PROBLEM: NOTE: For related information, see Bulletin SER 73 2-16, Oil Pan Modification.

On production Z1's before engine Z1E02984, the oil pressure warning light may come on and stay on under certain driving conditions. This most often occurs when the oil is hot and the motorcycle is rapidly accelerated. If the oil pressure warning light comes on, oil flow is cut off from the engine by the pressure switch. Sometimes this blockage can be overcome by revving up the engine (6,000 + rpm).

PROCEDURE:

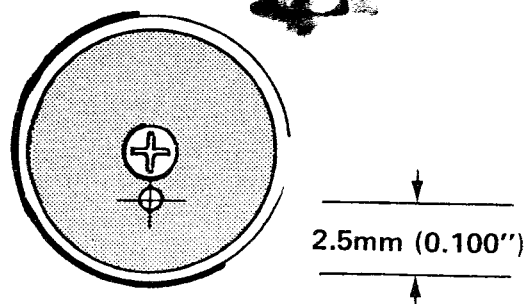
To prevent this problem from occurring, pressure must be relieved at the oil pressure switch. As long as flow is continuous through the switch, the oil pump will pick up oil and operate normally. By drilling a small 1/16" (1.5mm) hole in the bottom plate of the oil pressure switch, continuous oil flow is maintained and the oil pressure light will not stay on. The oil pressure light may flicker at high rpm, but the oil flow continues to the engine.

This hole is a standard factory modification to the oil pressure switch beginning with engine number Z1E-02984. Before this engine number, all oil pressure switches must have this hole drilled.

1. Disconnect the blue wire from the oil pressure switch.
2. Remove the oil pressure switch.
3. Mark and center punch the plunger disc at 2.5mm (0.100") from the edge. Drill a 1/16" (1.5mm) hole at this point.

CAUTION: Do not use a larger drill size, and make the hole location as precise as possible.

4. Re-install the switch and connect the blue lead.
